Final Environmental Impact Statement

Construction & Operation of a Tritium Extraction Facility at the Savannah River Site

COVER SHEET

TITLE: Final Environmental Impact Statement: Construction and Operation of a Tritium Extraction Facility at the Savannah River Site (DOE/EIS-0271)

Figure S-1. Tritium decay over time.

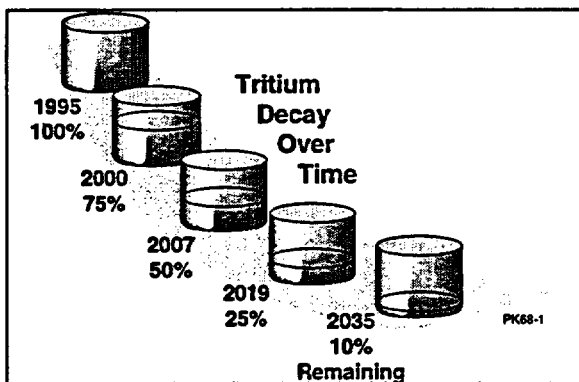
Comment M1-05 from the Economic Development Partnership contended that the EIS is deficient because it did not evaluate the impacts from the proposed Federal action to produce tritium for national defense purposes in commercial reactors. DOE believes that it will provide a complete evaluation in the programmatic and three site-specific EISs identified above. DOE has added the following text to the summary after the last paragraph on page S-1.

In response to public comments on the Draft Tritium Supply PEIS, DOE evaluated production of tritium for national defense in commercial reactors more thoroughly. DOE published a Notice in the *Federal Register* (60 FR 44327; August 25, 1995) to include this action as a reasonable alternative. Because of public comments on the Notice, public reviews of the Draft PEIS, and further consideration of nonproliferation issues, use of commercial reactors was evaluated as an additional reasonable alternative. The impacts of using CLWRs to produce tritium are described in the CLWR EIS and not in this TEF EIS. The purpose of this EIS is identified in the next section of this revised summary.
